9908030231 990726  
PDR ADOCK 05000346  
P PDR

Docket Number 50-346  
License Number NPF-3  
Serial Number 2608  
Enclosure 2

| 1. Relocate TS 3/4.3.3.2, 3/4.3.3.9 and 3/4.4.7 to the DBNPS Updated Safety Analysis Report Technical Requirements Manual. | These changes are to be implemented within 120 days after NRC approval of the License Amendment, and no later than the removal of TS 3/4.3.3.2, 3/4.3.3.9 and 3/4.4.7 from the TS. |

Base Figure 3-1 Incore Instrumentation Specification  
Acceptable Minimum AXIAL POWER IMBALANCE Arrangement

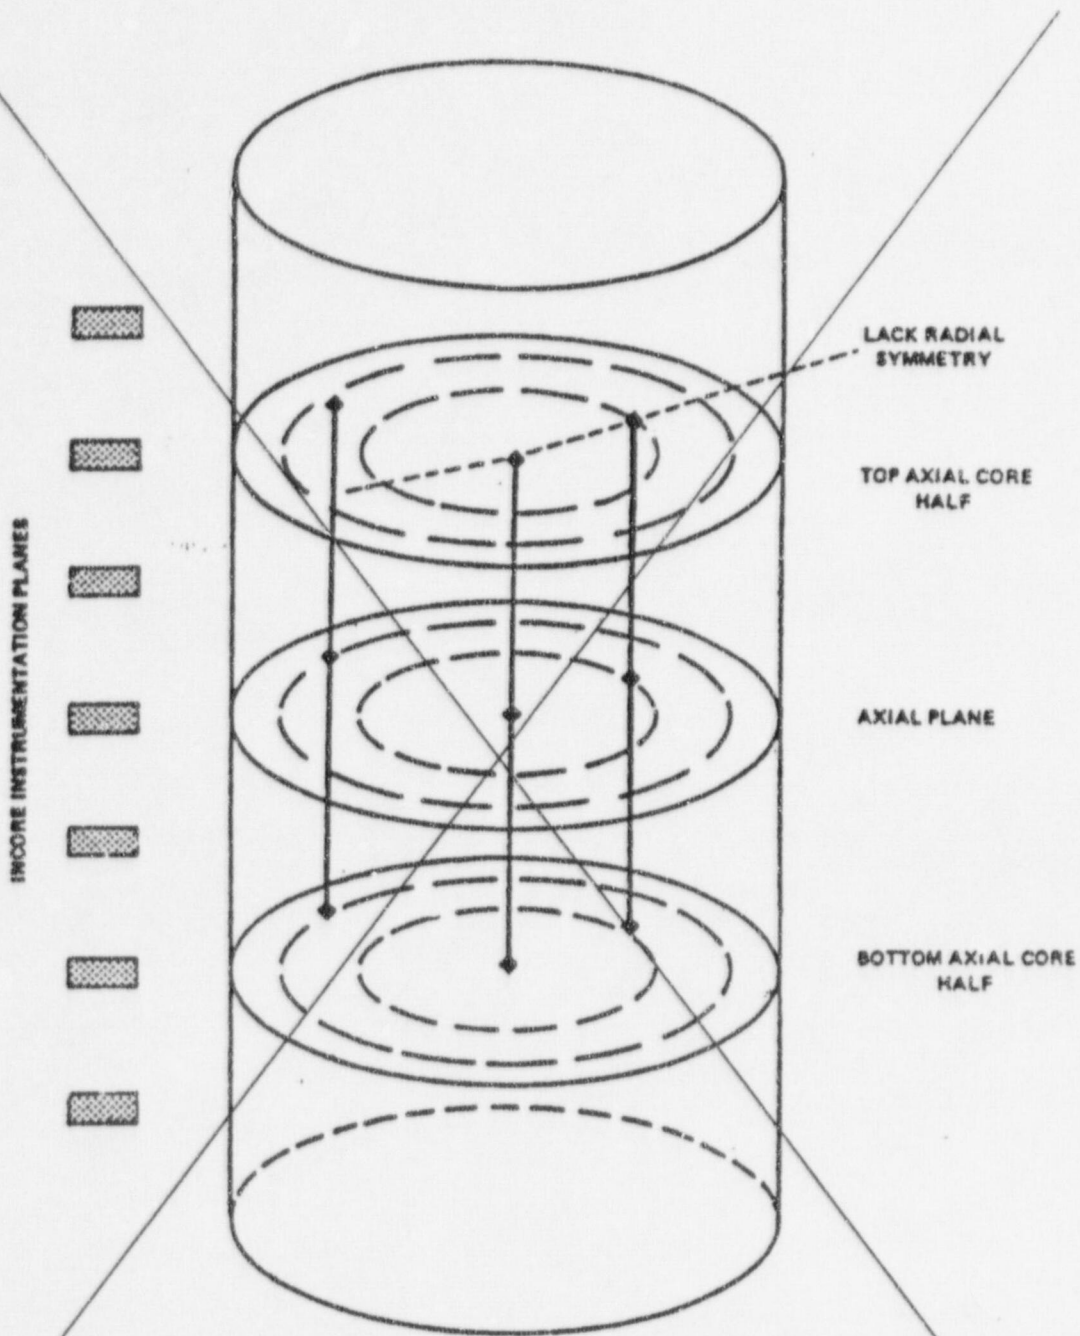
~~The OPERABILITY of the incore detectors ensures that the measurements obtained from use of this system accurately represent the spatial neutron flux distribution of the reactor core. See Bases Figures 3-1 and 3-2 for examples of acceptable minimum incore detector arrangements.~~

Deleted

Figure 3-2 In-core Instrumentation Specification  
Acceptable Minimum QUADRANT POWER TILT Arrangement

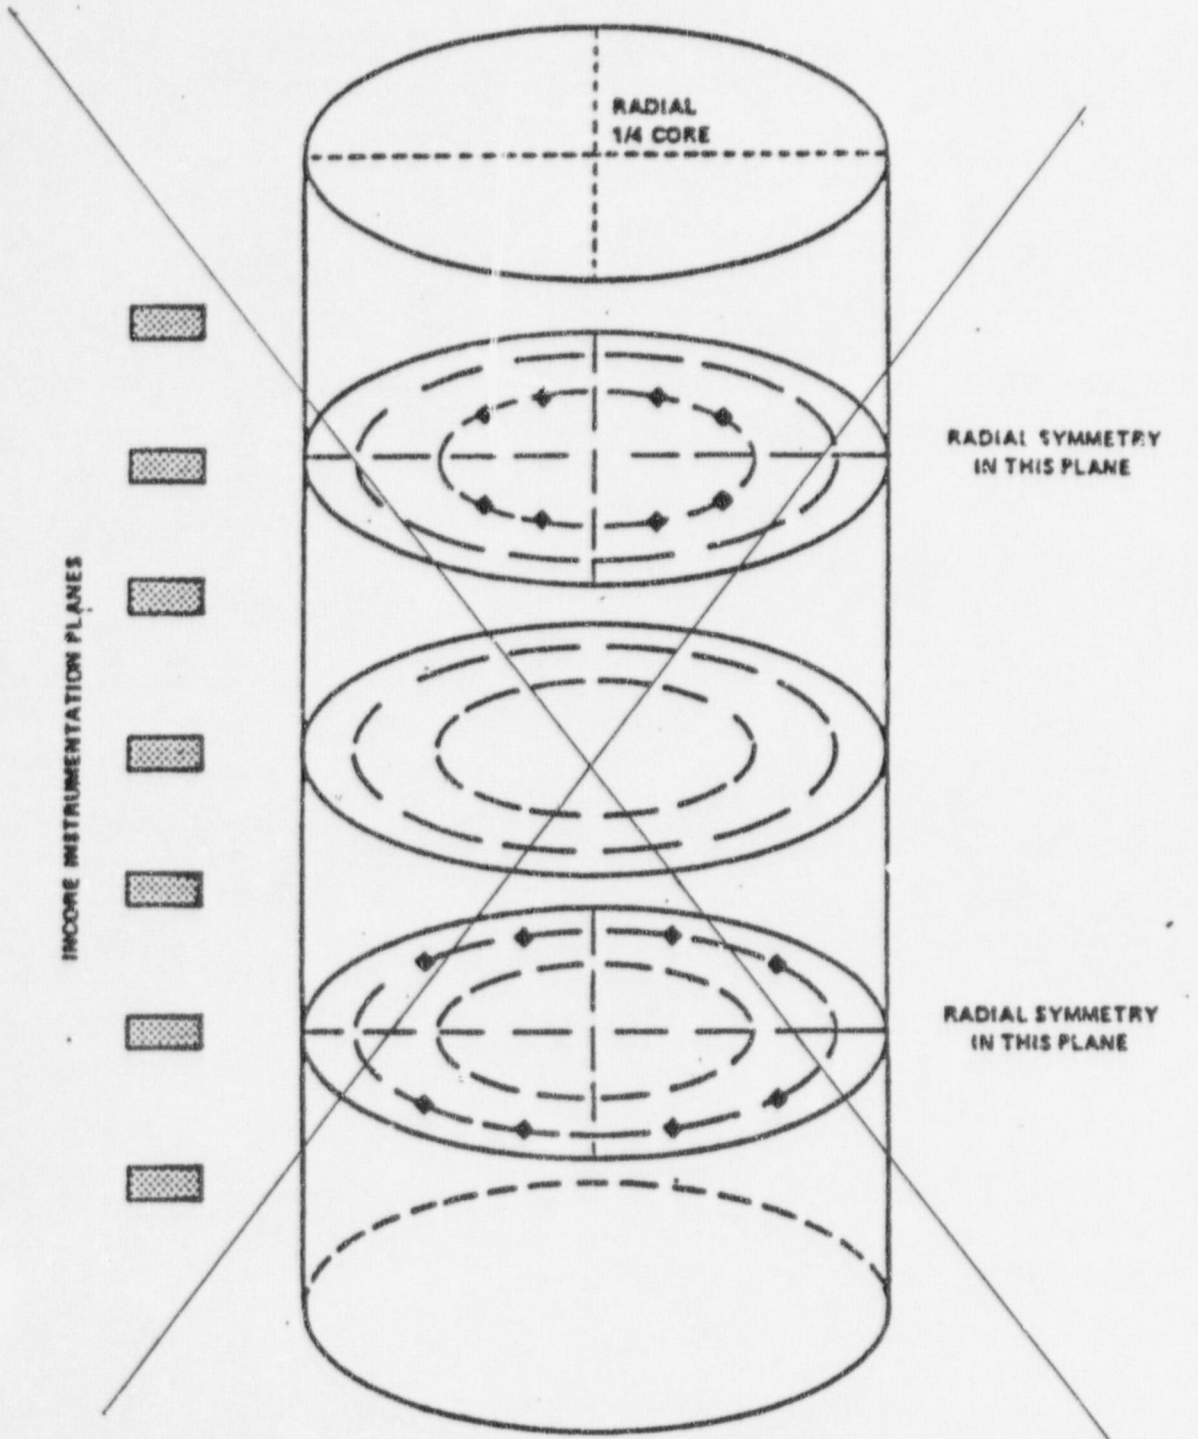
Deleted
